Purchasing Department 530 Water Street Oakland, CA 94607

ADDENDUM No. 1

Request for Quote No. 18-19/03 INF, OAK Fiber Optic Cable Installation

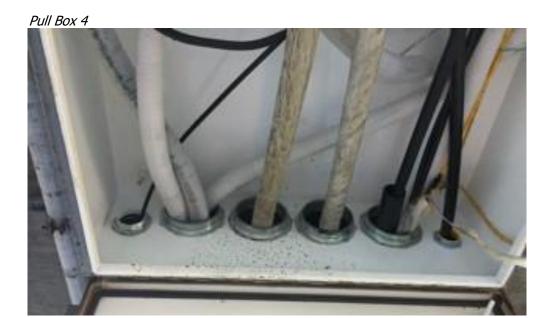
8. Question: Will photos of pull room 2 be provided?

Answer: Yes, pull room photo shown below.
